Ashperton Parish Council

Ref: Planning application 152041 as amended.
Land North of Ashperton Village Hall - Proposed residential development of 10 dwellings

The Parish Council therefore strongly OBJECTS to the proposed development and this objection replaces that dated 13th August. It is divided into three main sections, the objections, elaboration of objections 1 & 2 and a critique of the Amended Design and Access Statement (DAS), and in particular the Indicative Views.

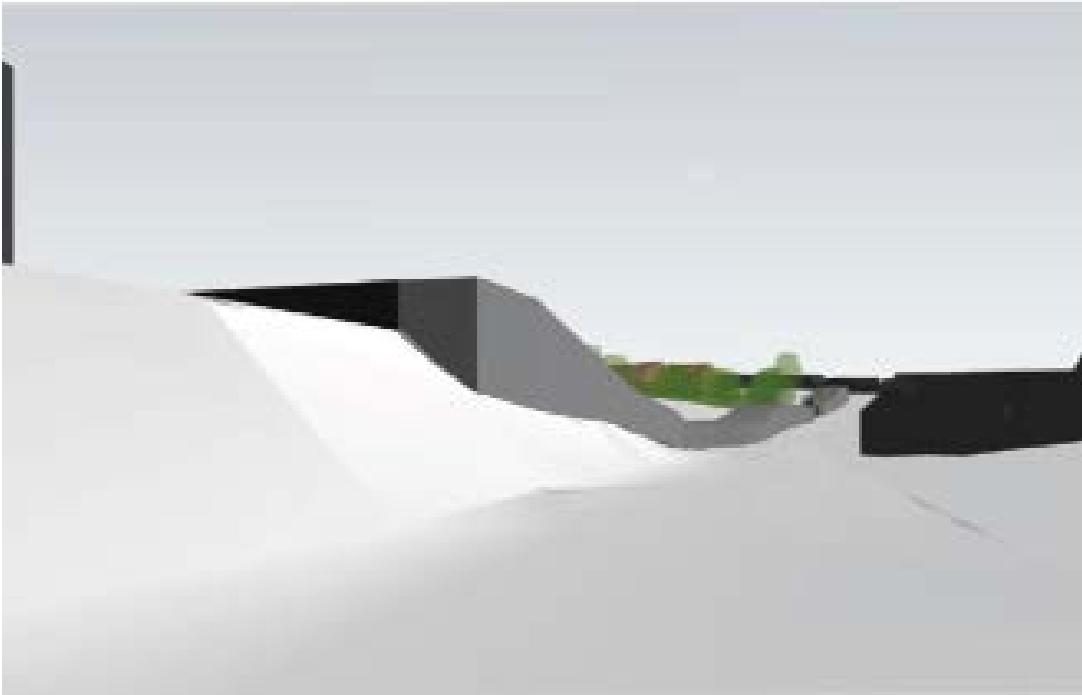
Indicative view from north 1. This view cannot be reproduced. As soon as buildings to the right side of the road come into view the "Old Police House" on the left cannot be seen. As with all the indicative views the existing buildings are shown in solid black/grey which exaggerates their bulk and mass whilst the proposed dwellings are shown in pastel orange which lessens their apparent impact. Compare with Google Streetview image from the same point on the road.

Note the dwellings on the right hand side of the road are screened from view and do not have the same appearance as indicated in the indicative view. The proposed dwellings would extend back from the road from a point in front of the Village Hall (indicated by blue arrow) across the view of No 52 (grade II listed) (indicated by orange arrow). Approximate extent of development indicated by the black line. Most of the iconic green sward would be lost.

Indicative view from north 2. Again massing and colouring of existing dwellings is deceptive. Effect of hedge exaggerated.

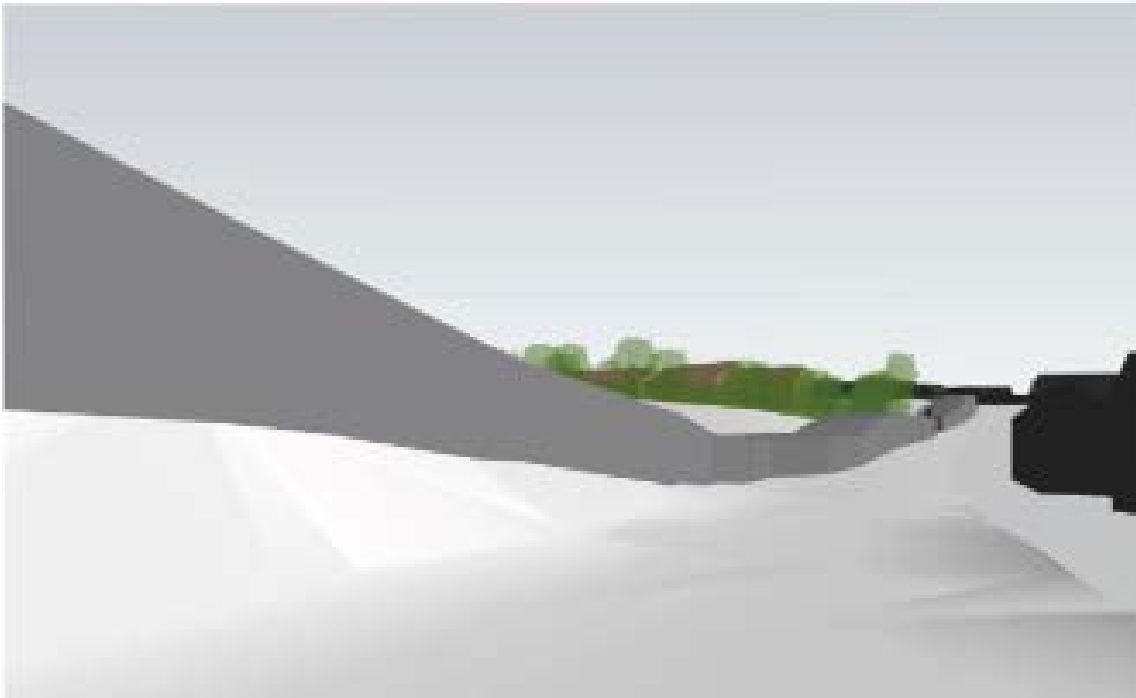
Same viewpoint as indicative view 2. Note existing buildings on right not visible let alone dominant in the view. Proposed dwellings would be highly visible extending back in depth from the main road.

Indicative view from north 3. The accompanying text suggests that "The orchard planting screens the southern (*sic*) cluster". The orchard planting no longer forms part of the application. Colouring again deceptive.

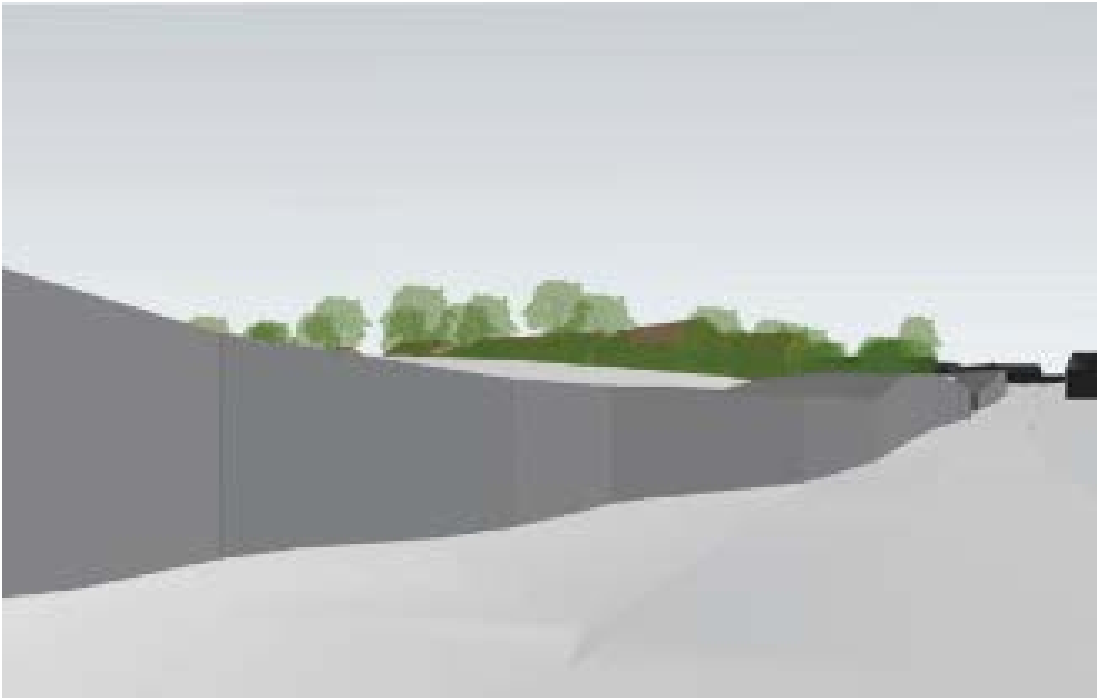
Looking south from the same viewpoint. The most easterly dwelling would be in front of the oak indicated by the green arrow not the one indicated by the red arrow which is in the field beyond. Note lack of screening by hedge and the depth of the proposed development. The proposed development would appear to cover most of the width of the sward.

Indicative view from north 4. Compare with Streetview.

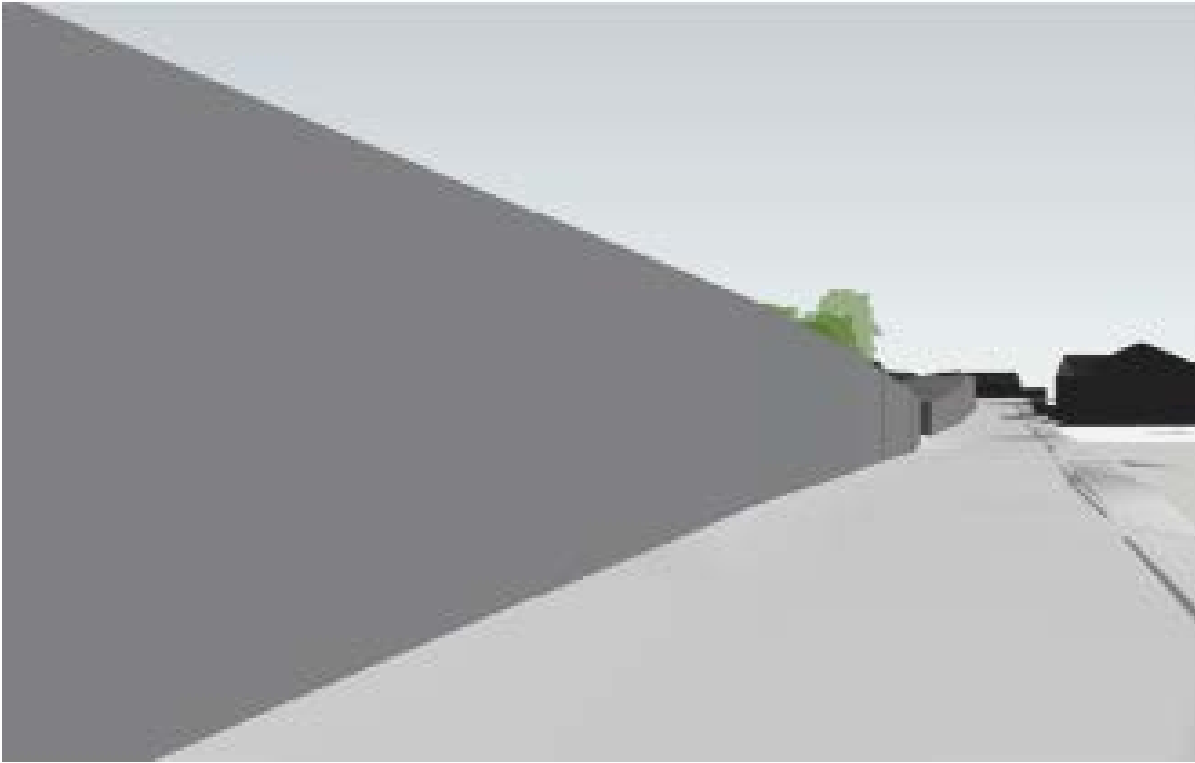
Whilst the floor level of some of the houses would be obscured by the highest ground, the highest point is only around 2m above the floor level of the most easterly of the dwellings and around the same level as the highest of the dwellings.

Indicative view from the north 5. Screening by hedge grossly exaggerated. Reference in text to the orchard being visible behind the hedge.

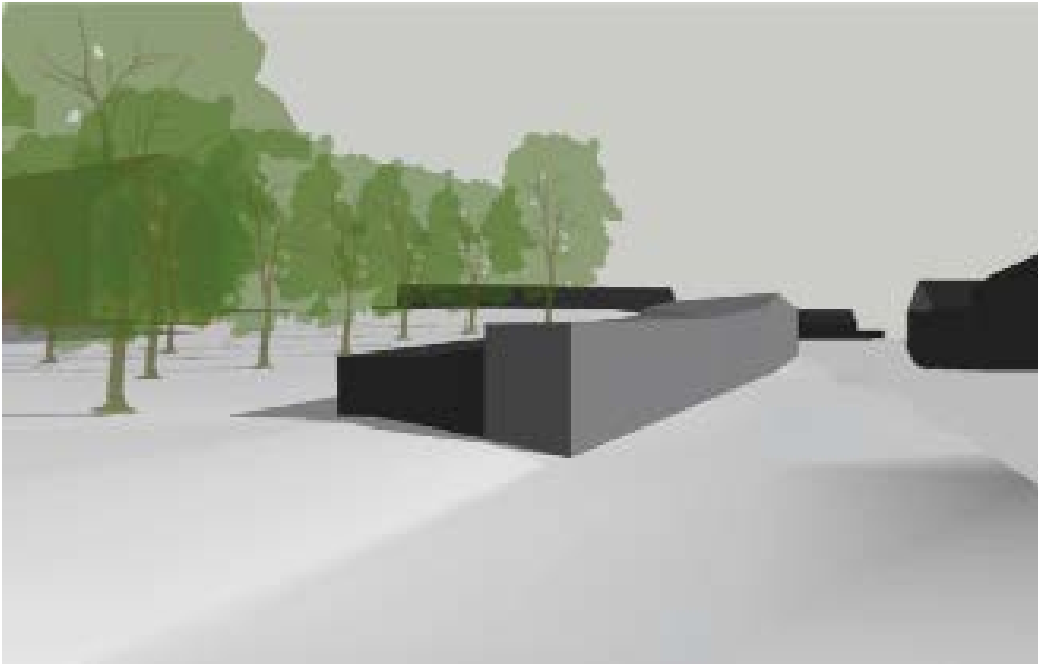
Development would be clearly visible behind/above hedge. Hedge would be cut back to provide visibility for the entrance in the approximate location of the car.

Indicative view from north 7. Cut back of hedge for visibility not shown and screening effect of proposed trees (in full leaf) appears exaggerated. Compare with view below which looks slightly more to the left.

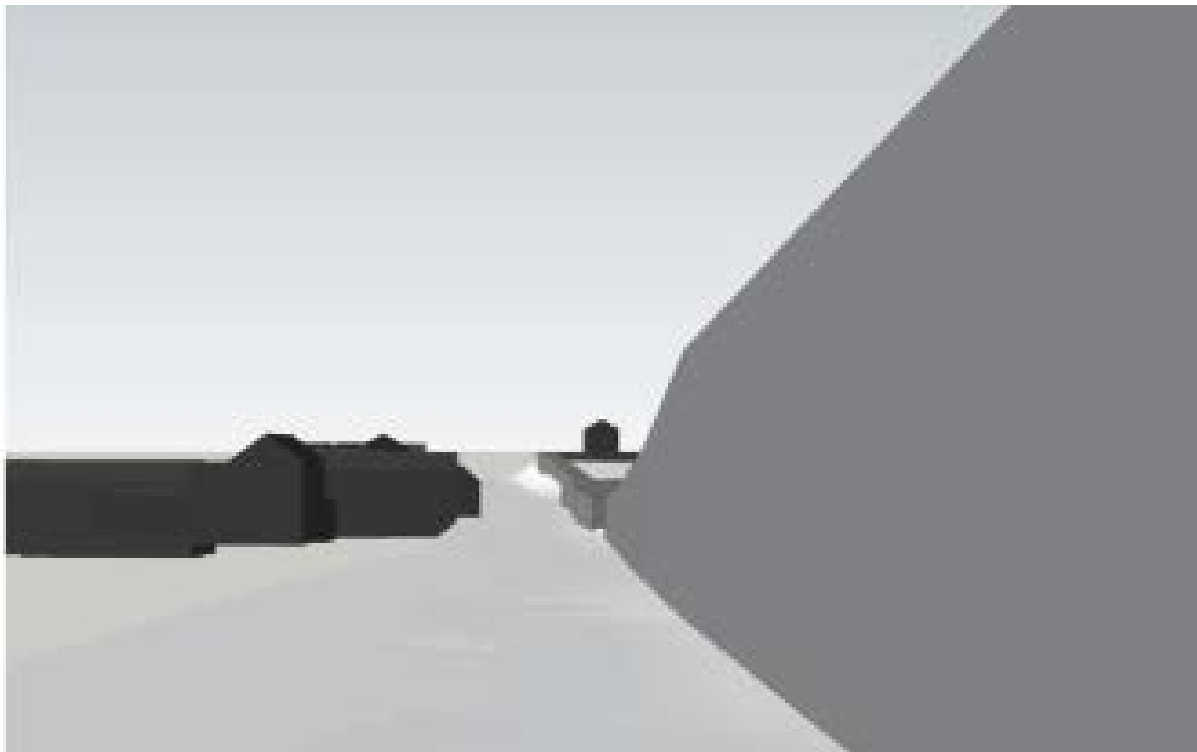
The access "Homezone" driveway would climb to a point approximately as indicated by the red arrow, almost 5m above the road at this point, with dwellings on either side. The most easterly dwelling would be located in front of the oak tree indicated by the green arrow.

Indicative view from the south 1

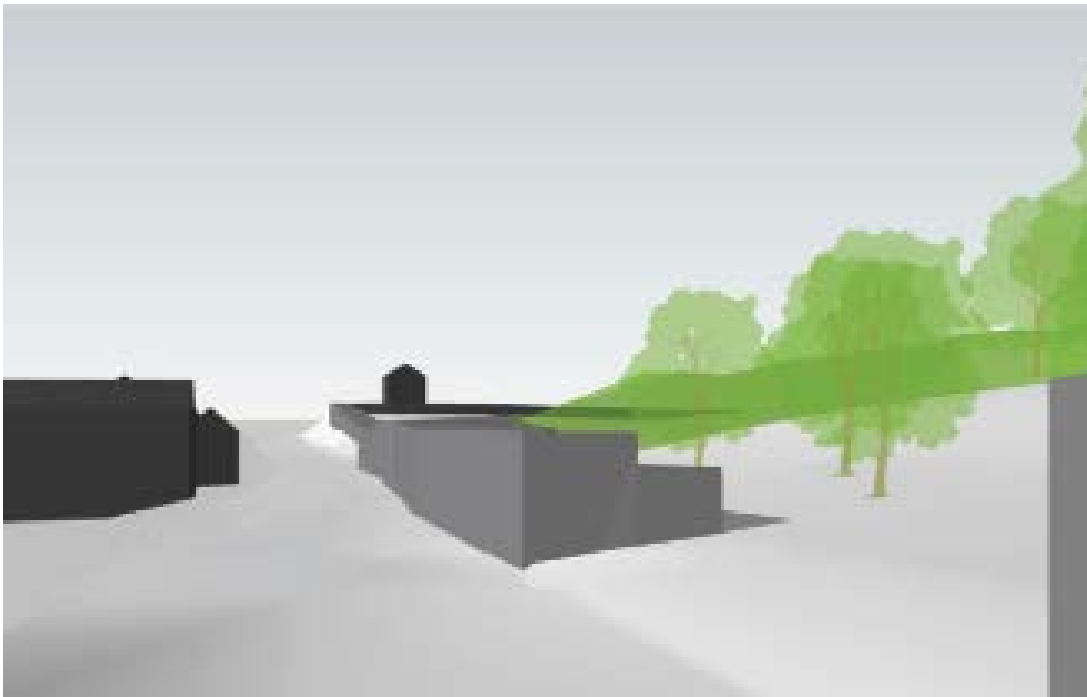
Similar viewpoint but northbound lane.
